Comments on Hi-Test Sand PSD Modeling Protocol Submitted by Kalispel Tribe of Indians October 2017

HiTest Sand, LLC (HiTest) proposes to construct and operate a silica smelter near Newport, WA along the Washington-Idaho state boundary. In support of an expected permit application under the Prevention of Significant Deterioration (PSD) regulations, HiTest has submitted an air quality dispersion modeling protocol for review by Washington Department of Ecology (Ecology). The protocol was prepared by HiTest's consultant, Ramboll Environ US Corporation. The Kalispel Tribe of Indians submits these comments to Washington DOE on the proposed modeling protocol.

Hoodoo, ID RAWS Station Wind Rose Period of Record: September 1, 2012 through August 31, 2017

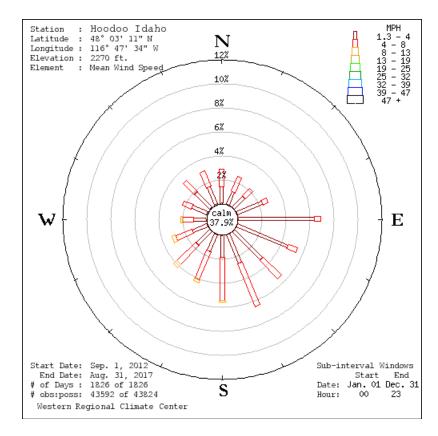
- 3. In order to better illustrate the Tribe's concerns over data representativeness, a wind rose from the Hoodoo, ID RAWS station is attached (Figure 1). Hoodoo is about 20 kilometers (km) southeast of the proposed plant site (Figure 2). The Hoodoo data show distinctly different wind patterns compared to the ID41 and Deer Park data. The Hoodoo data indicate a predominance of winds from the east through south sectors, winds that would carry plant emissions toward the Kalispel Reservation. At this time, the Tribe is not recommending that the Hoodoo data representativeness and quality as described elsewhere in these comments. However, the Hoodoo RAWS data show wind patterns more in line with expectations given the local topography of the area and illustrate why the Kalispel Tribe has concerns over the representativeness of the Deer Park and ID41 data recommended by the applicant.
